MARY E. RODMAN RECREATION CENTER RENOVATION

CONTRACT NO. 20814

ADDENDUM NO. 1

For: SPECIFICATIONS AND DRAWINGS

DEMOLITION PLAN

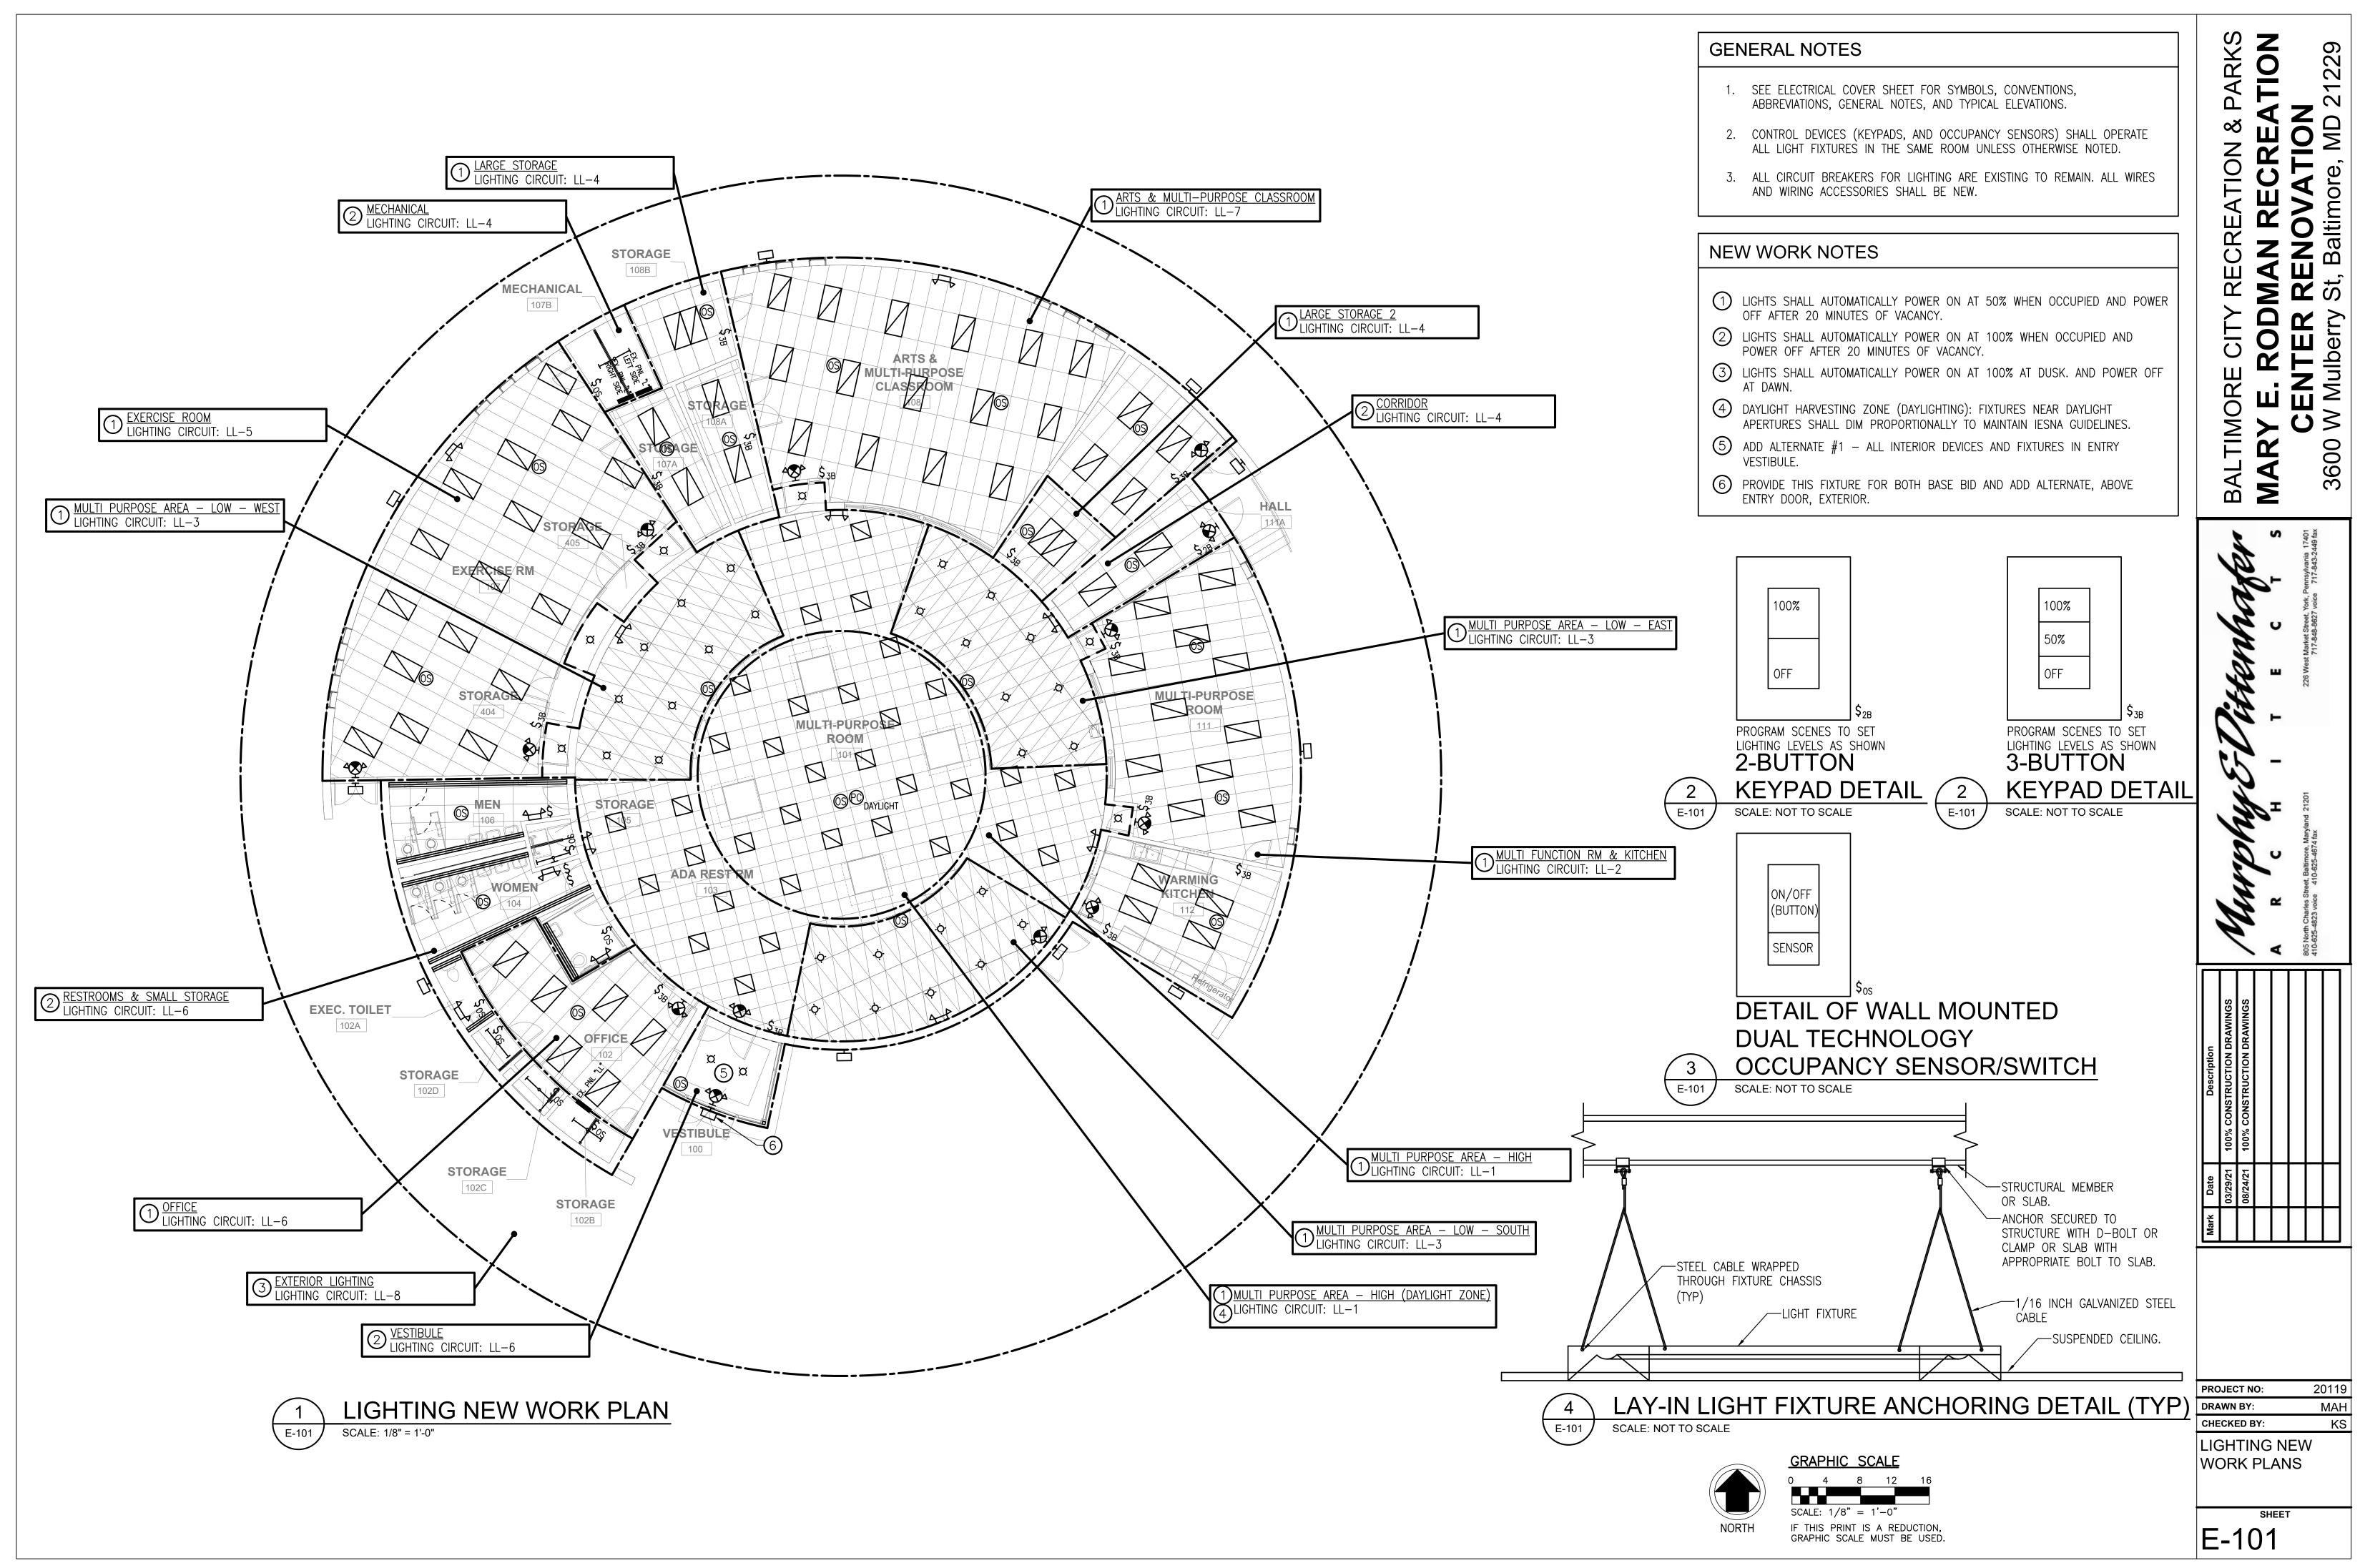
| 2.9 | Sheet | t A-400, Interior Elevations Multi-Purpose Room |
|-----|-------|---|
| 3.2 | Shee | et ED-101: |
| | 1. | Revised 104 Women, 106 Men. |
